KANSAS GAS AND ELECTRIC COMPANY

KMLNPC 81-110
Re: Docket Number STN 50-482
Ref: NRC Letter dated 8/7/81 from RL Tedesco, NRC,
to GLKoester, KG&E

The referenced letter requested additional information in the area of geotechnical engineering. Transmitted herewith are responses to questions in the referenced letter. The outstanding response to question 241.5 WC, Items 2 thru 5, will be forwarded to you on October 1, 1981. This information will be formally incorporated into the Wolf Creek Generating Station, Unit No. 1 Final Safety Analysis Report in Revision 6. This information is hereby incorporated into the Wolf Creek Generating Station, Unit No. 1 Operating License Application.

FIGURE 241.1-1
RECOMMENDED SHEAR MODULUS
VERSUS SHEAR STRAIN CURVE FOR
CRUSHED ROCK STRUCTURAL FILL

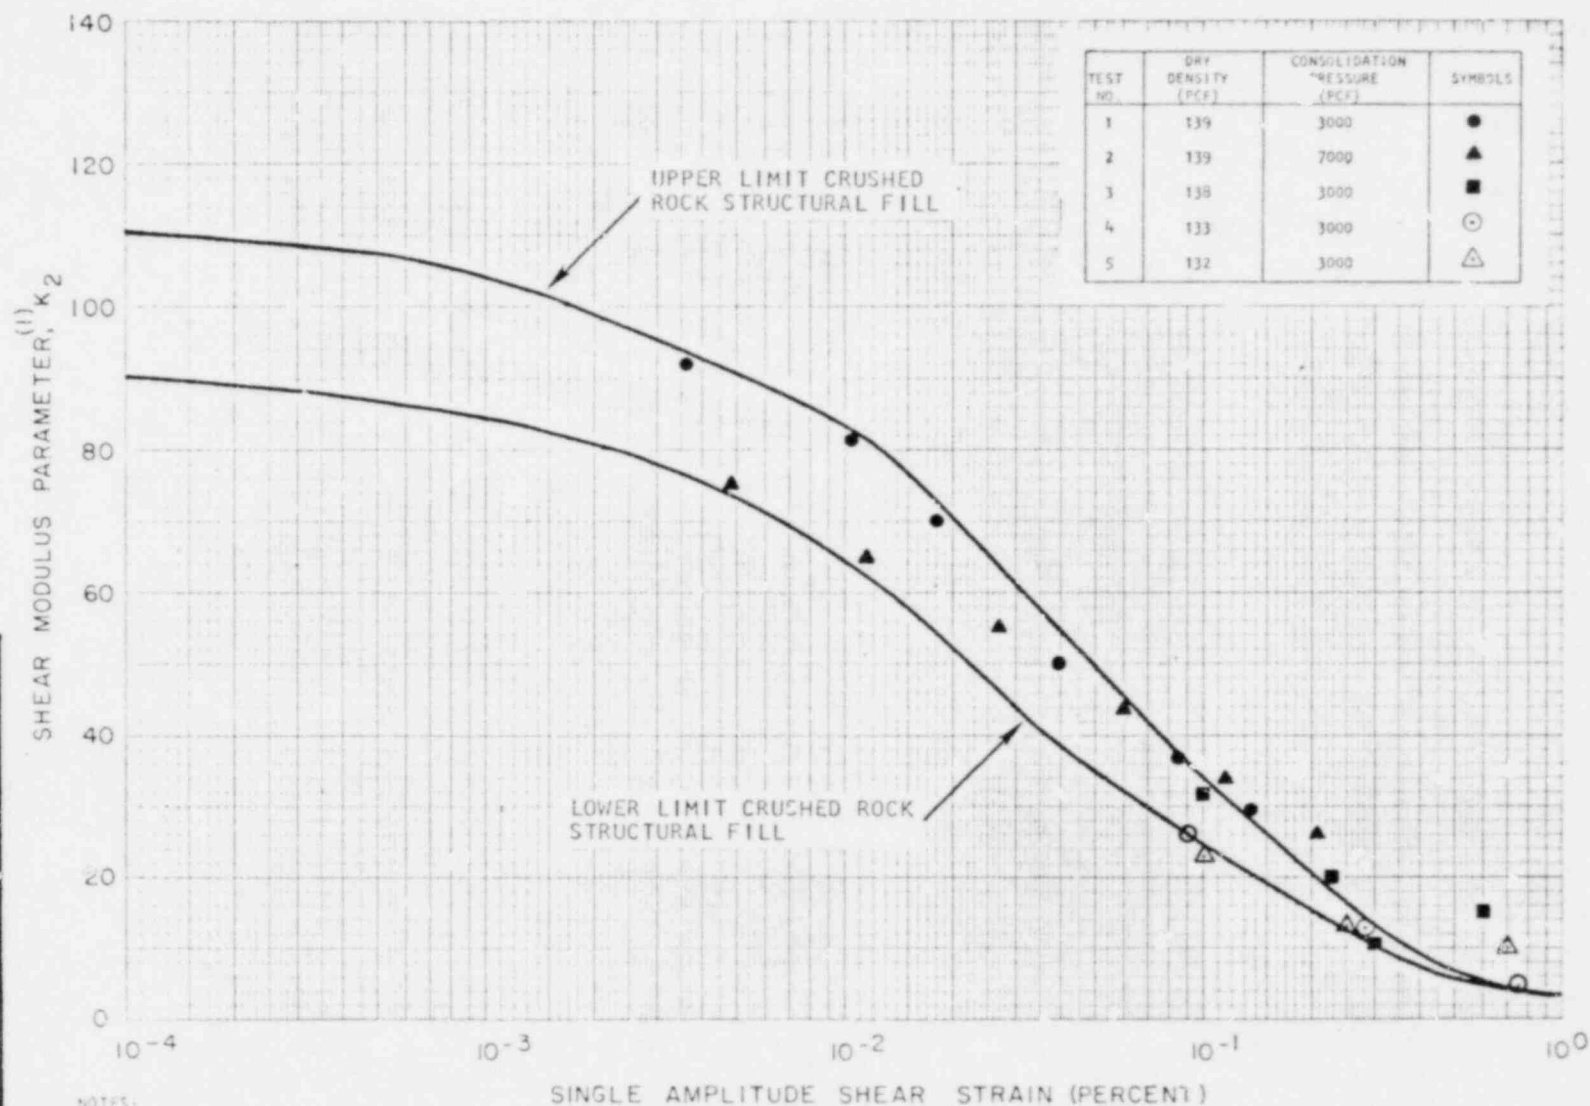
Q241.1 In Figure 2.5-97a through 2.5-97e show the data points used in developing these curves. Also plot the mean and the standard deviation curves.

R241.1 Data points have been added to Figures 2.5-97d and e, Figure 241.1-1 and 241.1-2. No dynamic tests were performed on the pipe bedding material, since several alternative materials were to be used as pipe bedding. The pipe bedding materials ranged in gradation from gravelly sand to medium sand with little or no fines (see response to Question 241.3). The shear modulus range and strain degradation curves (Figure 2.5-97c) were, therefore, chosen as those for dense sands and gravelly sands as presented in "Soil Behavior Under Earthquake Loading Conditions"; State of the Art Evaluation of Soil Characteristics for Seismic Response Analysis; Shannon and Wilson, 1972.

FIGURE 241.4-1

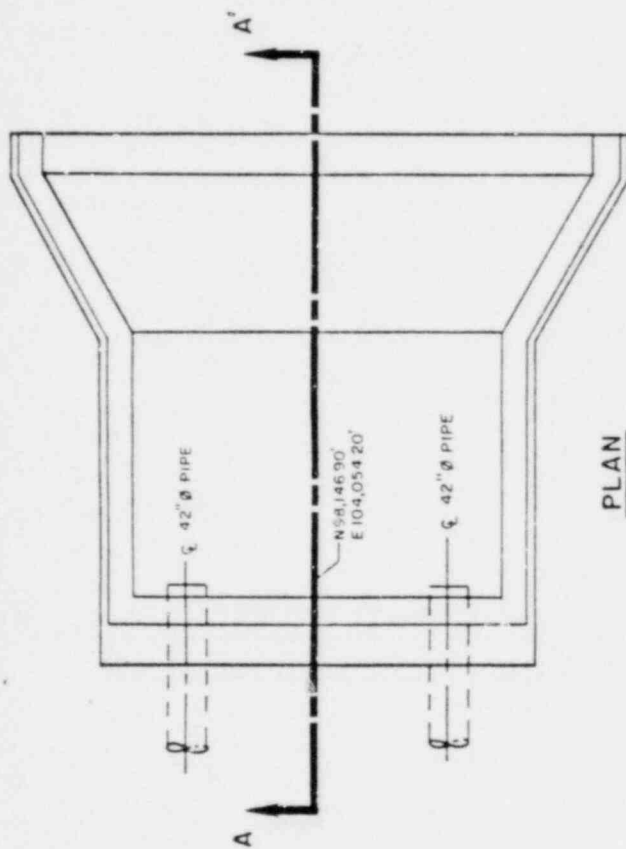
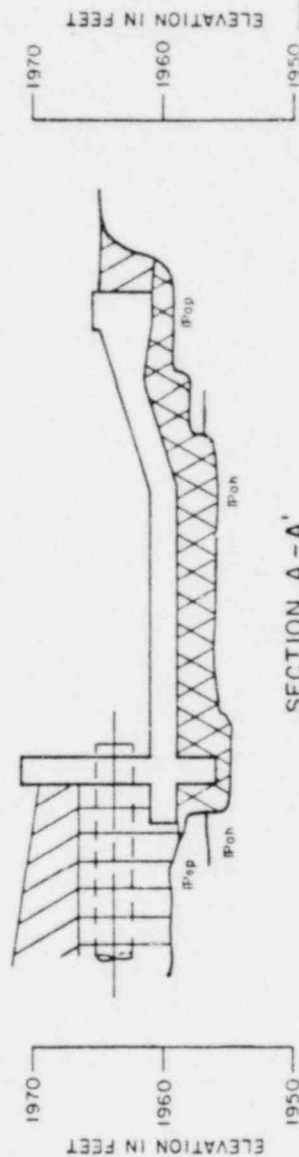
- Q241.4 For the ESWS discharge structure, submit drawings showing plans and typical cross-sections of the limits of excavation and types of fill and back-fill materials.
- R241.4 The information is provided on Figure 241.4-1.

Fig. 24'.7-1

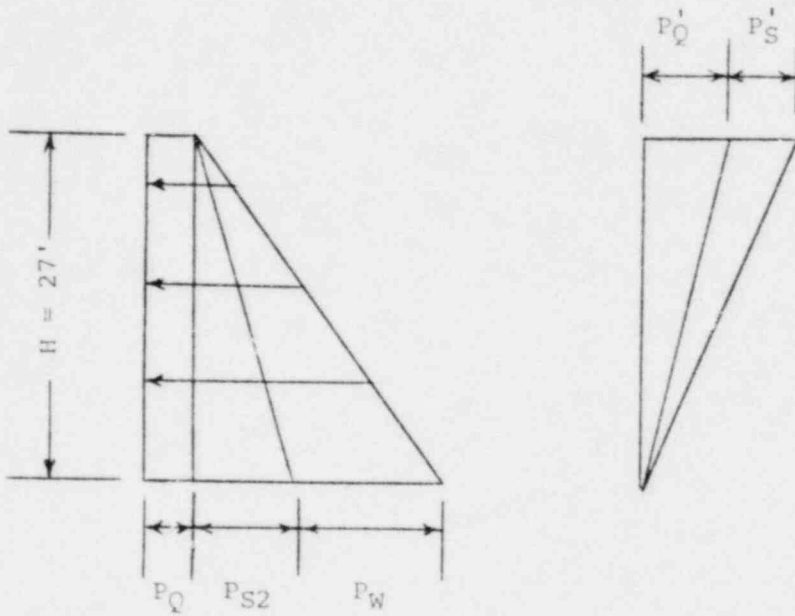
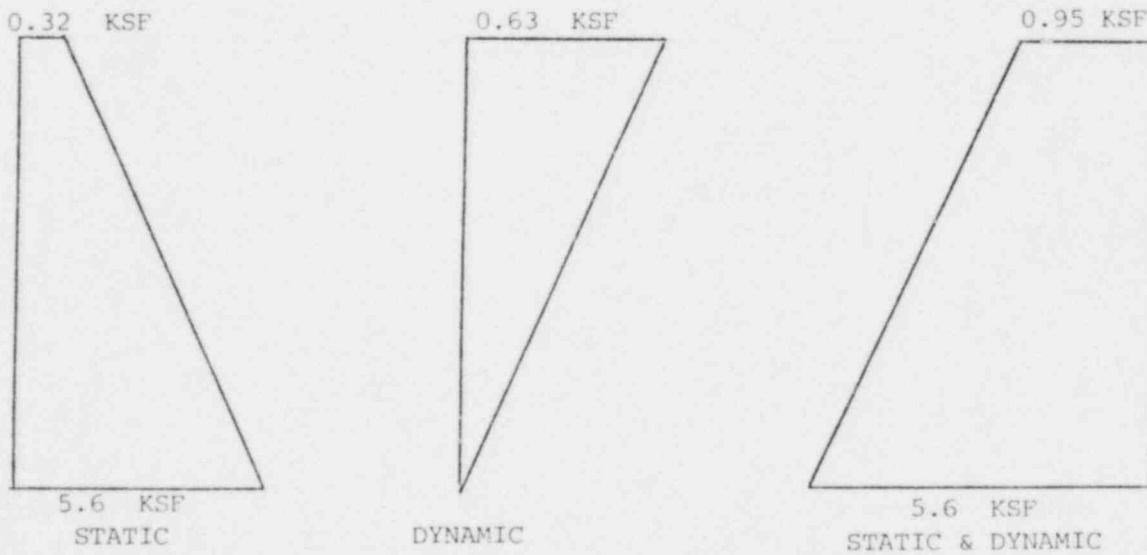
Q241.7
(2.5.4.10.1.3) Provide a plot of the magnitude and distribution of lateral earth and water pressures used in the design of subsurface walls and, on the same figure, plot the dynamic lateral pressures computed from the soil-structure interaction analyses due to the building and soil response under dynamic loading conditions. Provide such plots for the main powerblock structures, the ESWS pumphouse, and the ESWS discharge structure.

R241.7 The plots of the magnitude and distribution of lateral earth and water pressures as well as dynamic lateral pressures are provided in Figures 241.7-1 through 241.7-6.

FIGURE 2.5-112

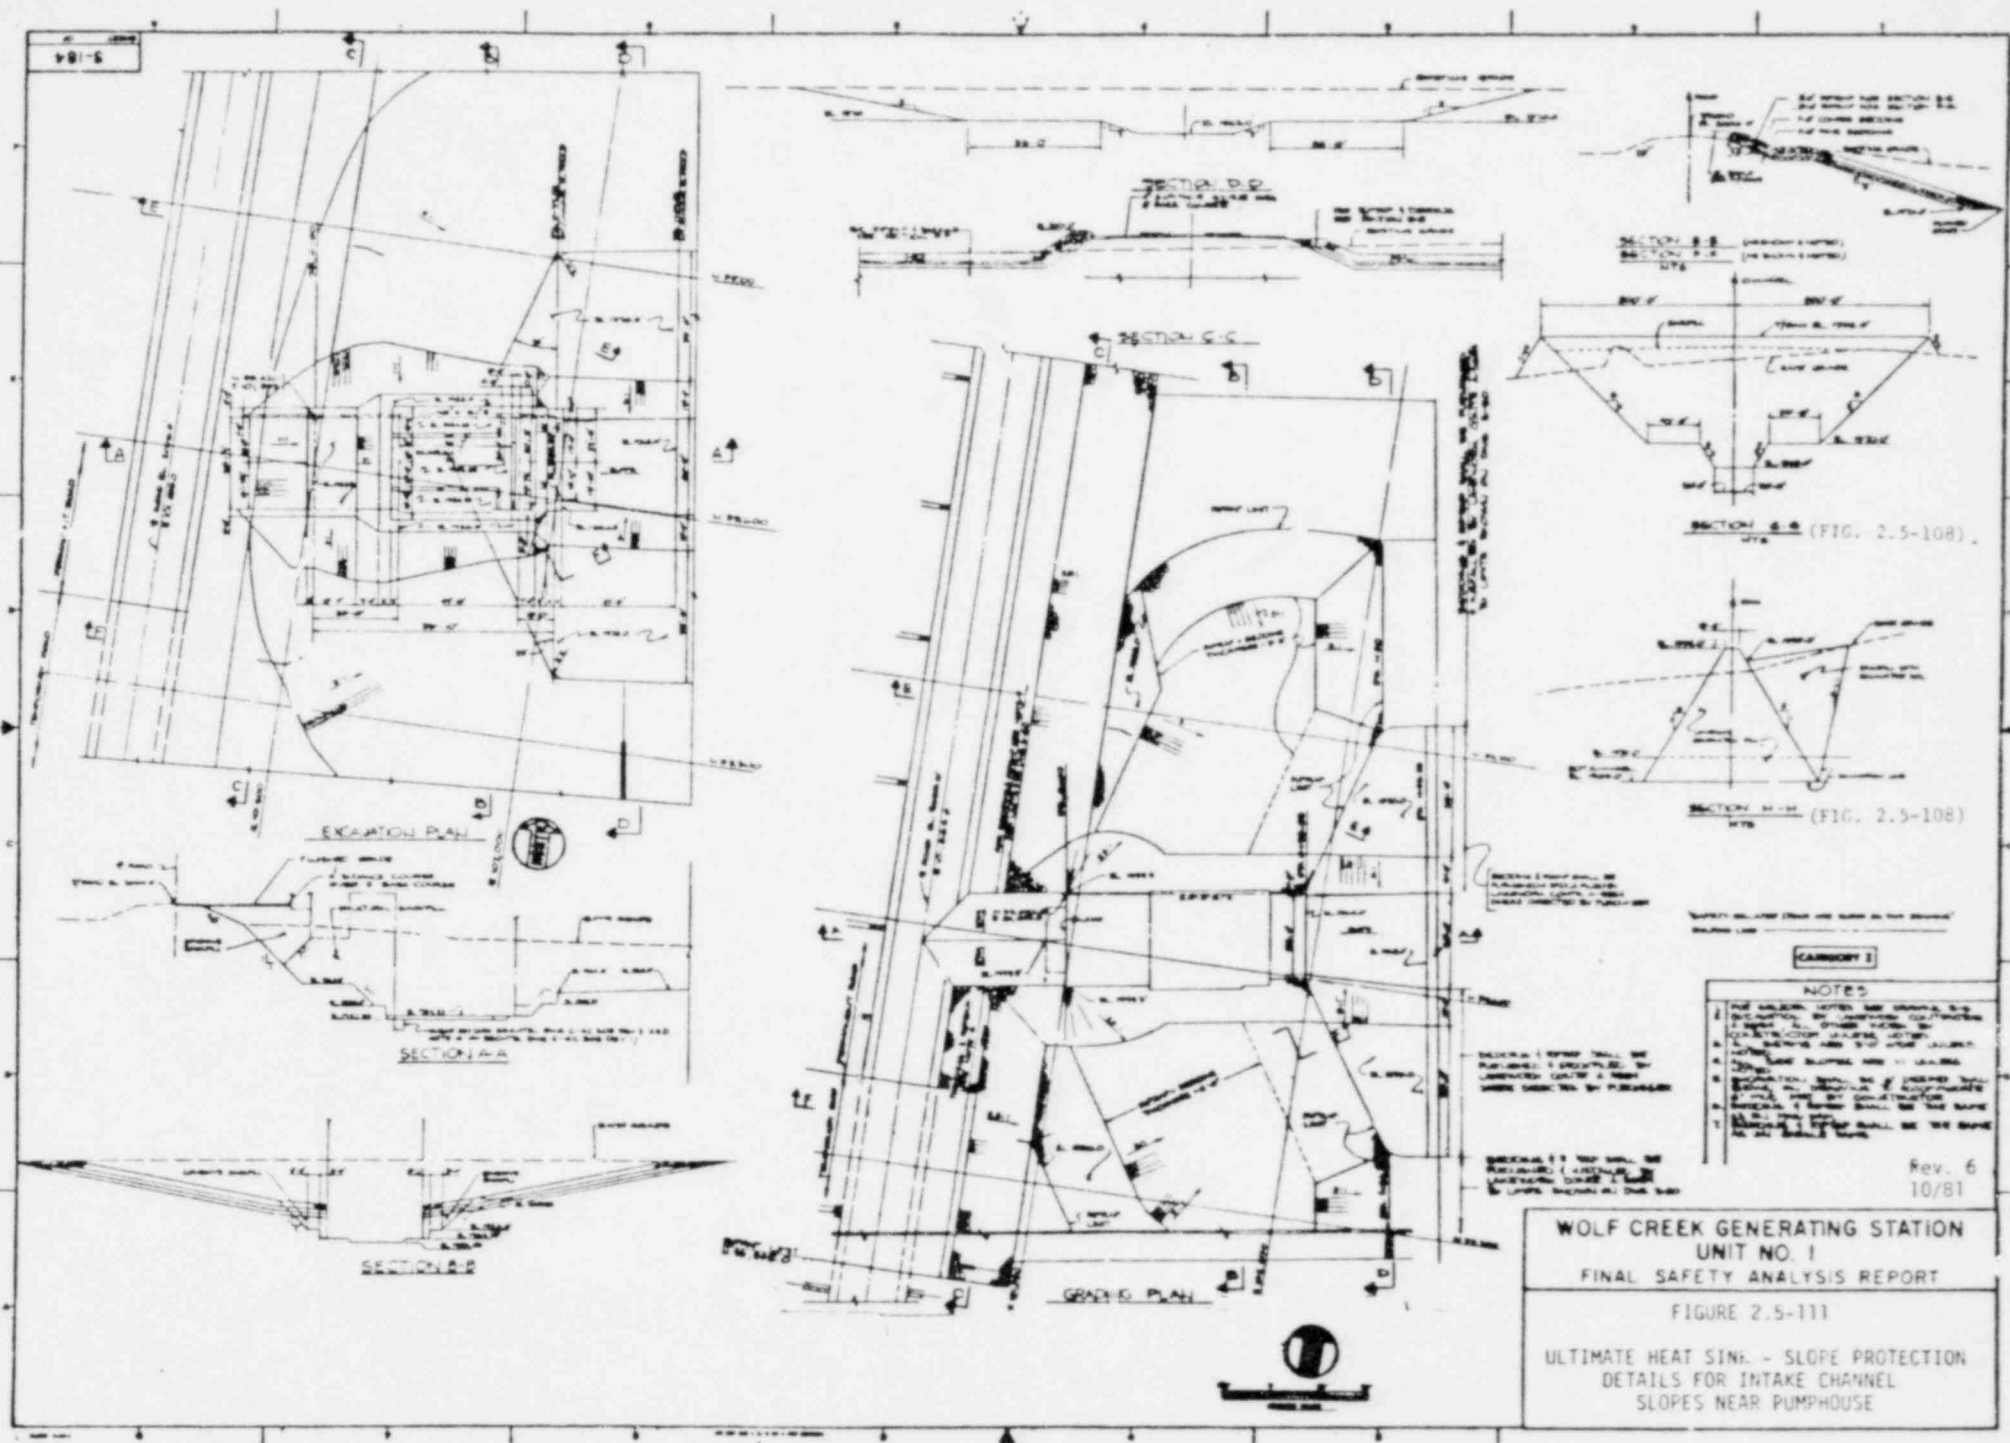
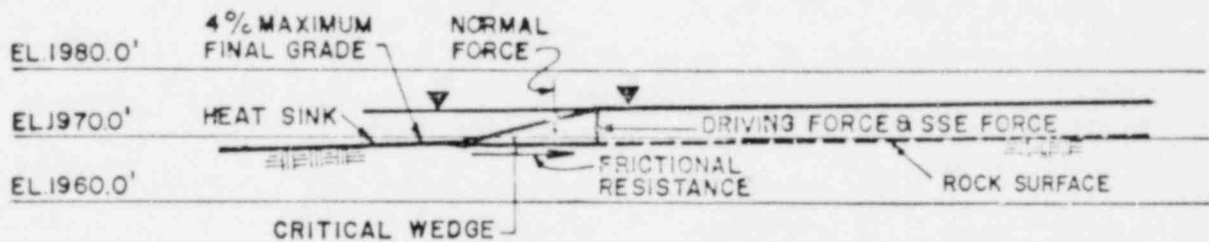
Q241.9 In Figure 2.5-112 show the following missing
(Figure information.
2.5-112)

- a) The water levels and the piezometric surfaces
 used in the stability analyses for all con-
 ditions analyzed.
- b) Show the minimum factor of safety and the
 corresponding critical sliding wedge.

R241.9 Figure 2.5-112 of FSAR has been revised to show
the water level and identify the critical failure
wedge, soil parameters and minimum factor of safe-
ty for the cases investigated. The critical fail-
ure wedge is the same for each of the cases.

FIGURE 2.5-1113a

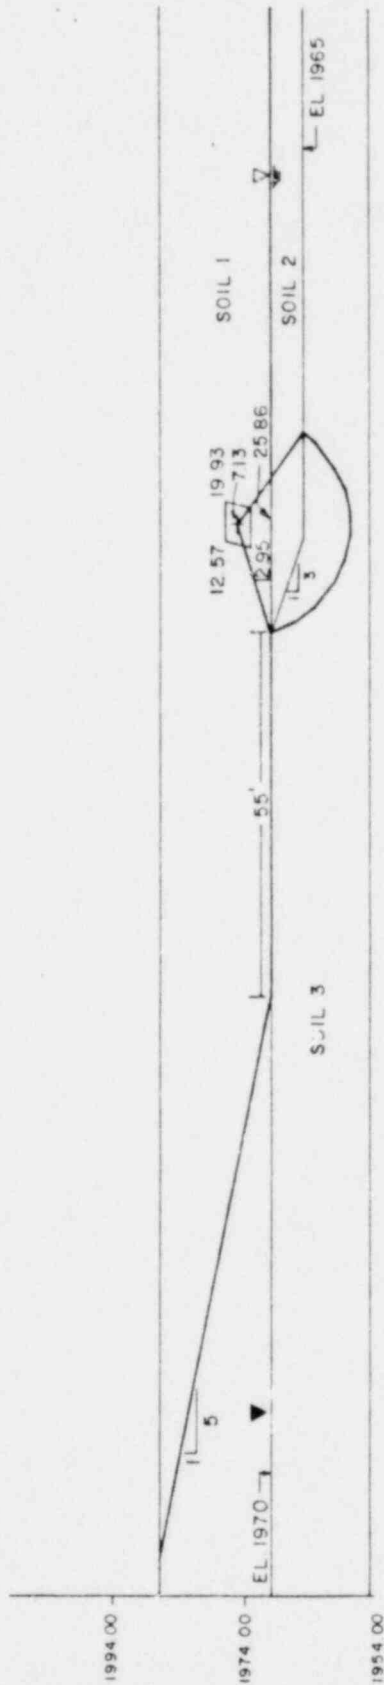
Q241.10 1. In Figure 2.5-113 show the following missing
(Figure information:
2.5-113)

- a. Subsurface soil profile and the soil
 parameters for each soil layer that were
 used in the slope stability analyses.
 - b. Show the water levels and the piezo-
 metric surfaces used in the stability
 analyses for all conditions analyzed.
 - c. Show the minimum factors of safety and
 the corresponding critical slip circles
 for each of the cases investigated.
2. Discuss the validity of using slip circle
method of analysis, particularly for the side
slopes of the pumphouse intake channel
(3H:1V), considering that a) the hard rock
layer is in the immediate vicinity of the
toe of the slope, b) for the UHS slope you
choose to use the sliding wedge method of
analysis. Justify the validity of the slip
circle method of analysis or investigate the
stability of the slopes of the ESWS pumphouse
intake channel using the sliding wedge method.

R241.10 1. The information requested is shown on Figures 2.5-113a through 2.5-113h. Section 2.5.5.2.2.2 had been revised to include a reference to these figures.

FIGURE 2.5-115a

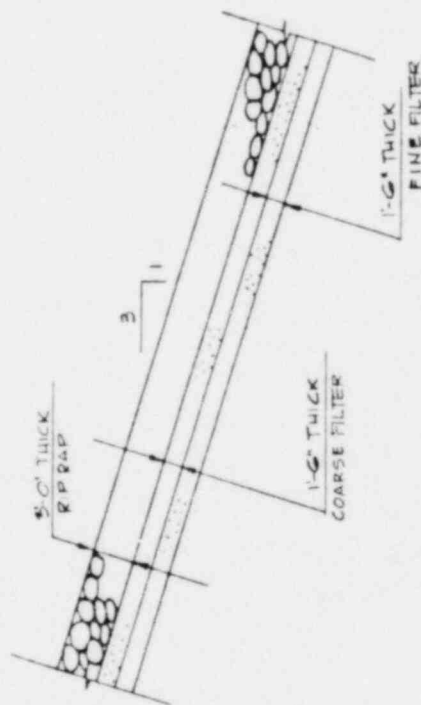
Q241.11 Show the critical slip circle and the corresponding minimum factor of safety for the cases investigated in the stability analyses presented on Figure 2.5-115. Also, correct Detail A that shows the fine filter layer between the coarse filter layer and the riprap layer.

R241.11 Figures 2.5-115B through 2.5-115d show the critical slip circles and Factors of Safety for the cases investigated. Section 2.5.6.5.1.2 has been revised to include a reference to these figures. Detail A on Figure 2.5-115 (this is now Figure 2.5-115a) has been corrected.

**WOLF CREEK GENERATING STATION
UNIT NO. 1**
FINAL SAFETY ANALYSIS REPORT
FIGURE 241.13-1
**UHS DAM - EARTH FILL EMBANKMENT
STATISTICAL DISTRIBUTION PLOT**

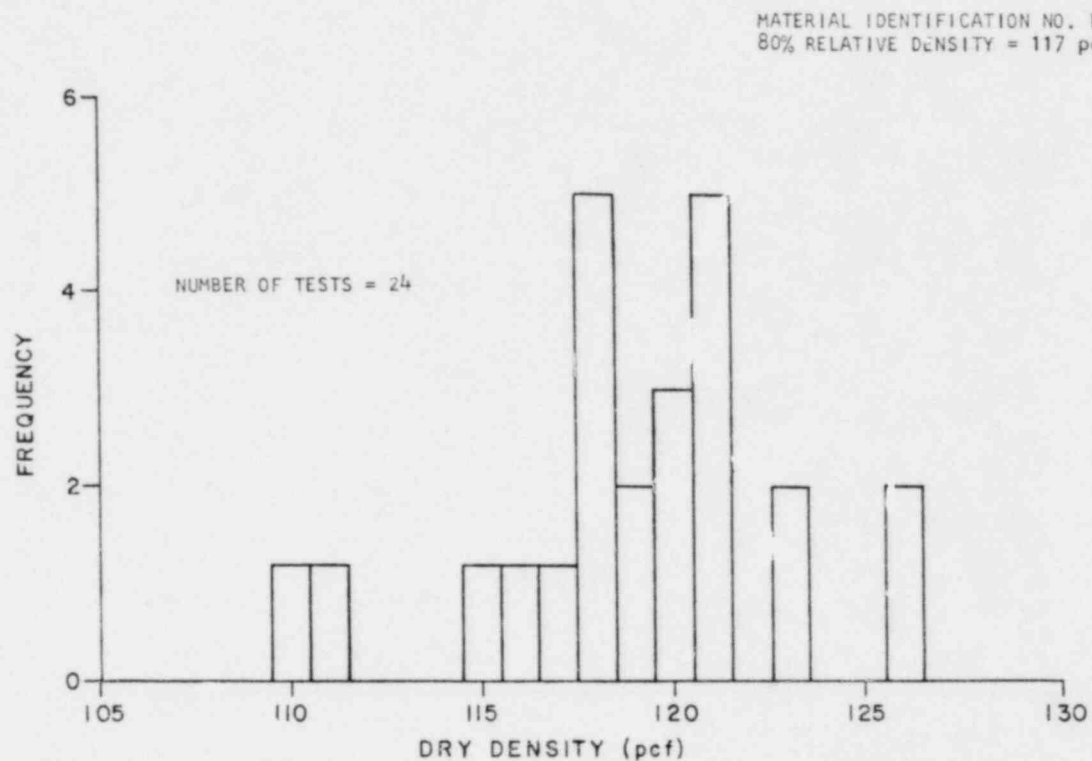
Q241.13 Provide a summary of the results of field density and moisture content tests performed in connection with quality control during construction of the UHS dam. Present the results as a statistical distribution plot or by other convenient method(s) to verify that the specified compaction has been attained. Compare the compacted in-situ density and moisture content of the embankment fill with those of the test specimens from which the design strength parameters have been determined by laboratory testing. Based on the above comparison, comment on the validity of the physical and strength parameters used in the design.

R241.13 The summary of the field density tests are shown on Figures 241.13-1 and 241.13-2. Based on the field tests, 16 of the 195 field tests failed to meet the compaction criteria by 1 to 4 percent compaction. However, all failed areas were recompacted, or the failing material removed and replaced. Moisture content data are summarized on Figure 241.13-4.
